UNITED STATES
NUCLEAR REGULATORY COMMISSION
WASHINGTON, D.C. 20555-0001
January 16, 1997

SUBJECT: CORRECTIONS TO AMENDMENT 176, IMPROVED TECHNICAL SPECIFICATIONS, H. B. ROBINSON STEAM ELECTRIC PLANT, UNIT NO. 2 (TAC NO. M96440)

TS Page 3.4-8

Figure 3.4.3-2
Reactor Coolant System Cooldown Limitations
Applicable Up to 24 EFPY

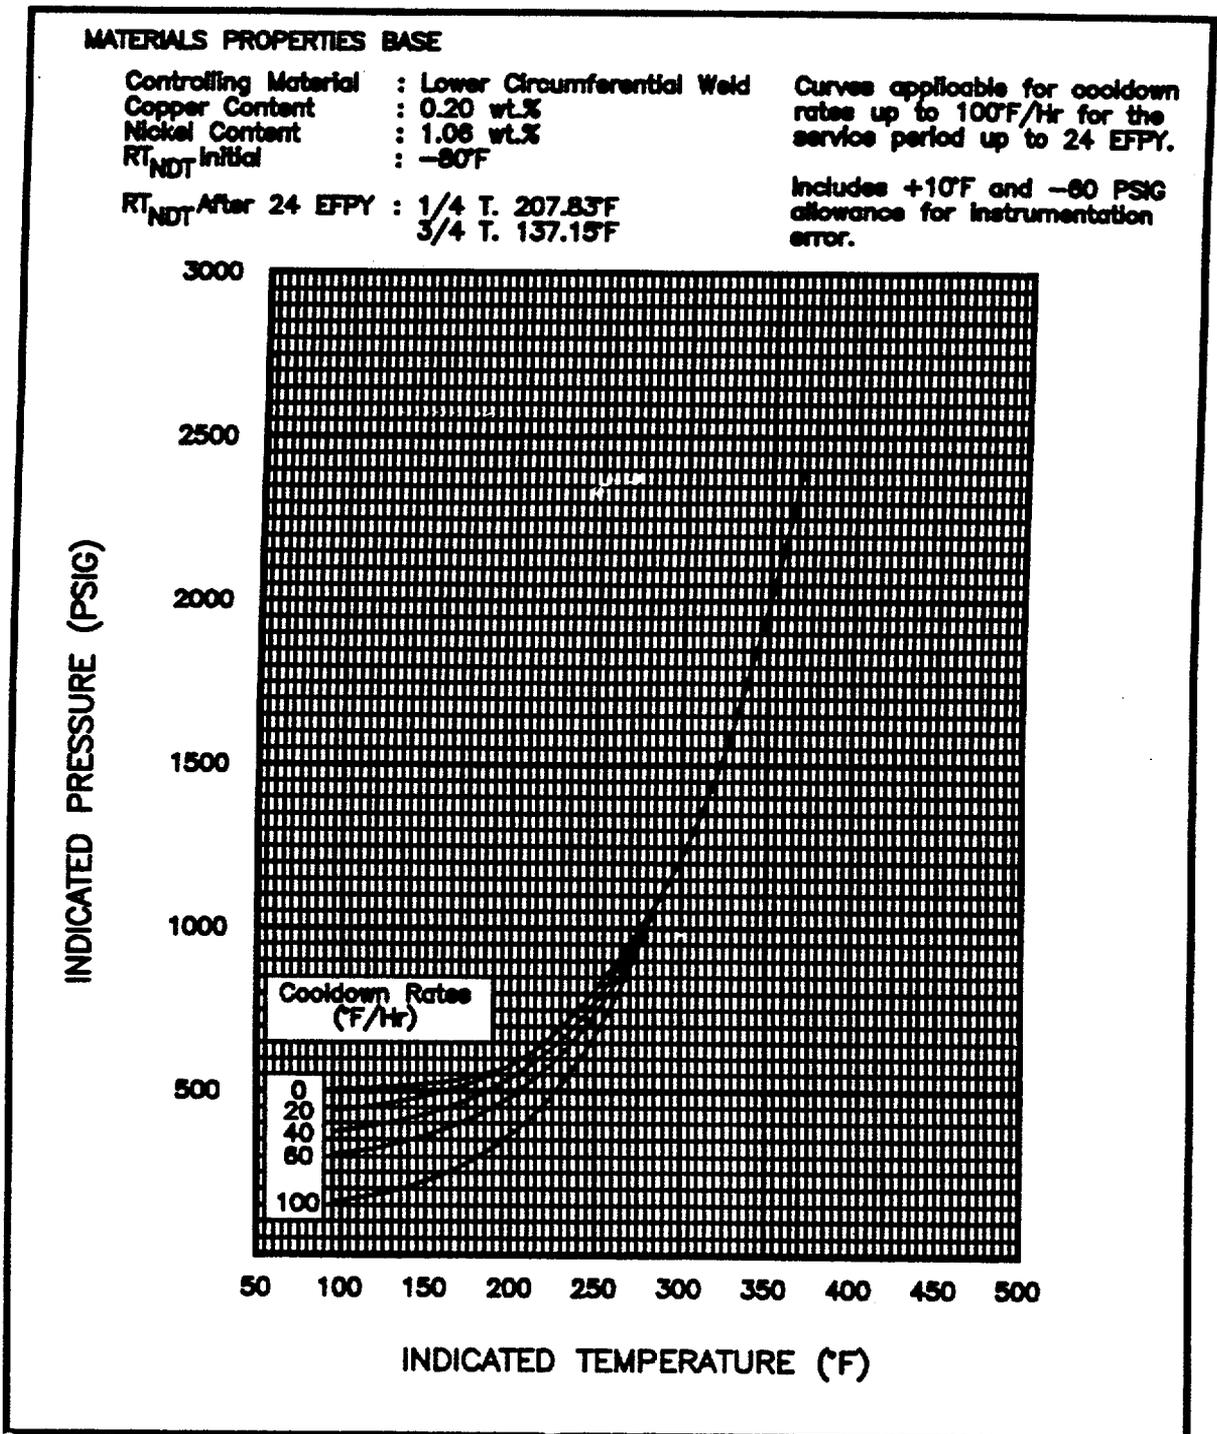
Upon review of the completed amendment, your staff discovered one minor concern with the as-issued amendment. Page 3.4-8 contained Figure 3.4.3-2 which was labeled "Reactor Coolant System Cooldown Limitation Applicable Up to 24 EFPY." The curves included in that figure were not the cooldown limitation curves, rather they were an unintended and incorrect duplication of the reactor coolant system *heat up* limits. The heat up limits were correctly included as Figure 3.4.3-1 of the as-issued ITS.

The staff reviewed this error and determined that the error was made subsequent to Carolina Power and Light Company's August 27, 1996, request for conversion to the ITS and did not occur in any of the subsequent submittals made by CP&L which revised the original request. In the August 27, 1996, application, the only changes proposed by CP&L to the heat up and cooldown curves were administrative changes to renumber the associated Figures to match the ITS numbering scheme. No technical changes were requested by CP&L nor considered by the staff during the course of its review. The incorrect substitution in Figure 3.4.3-2 occurred during processing of the final version of the ITS just prior to issuance of the amendment.

Enclosed is a corrected version of Figure 3.4.3-2 which reflects the curves originally proposed by CP&L in the August 27, 1996, application.
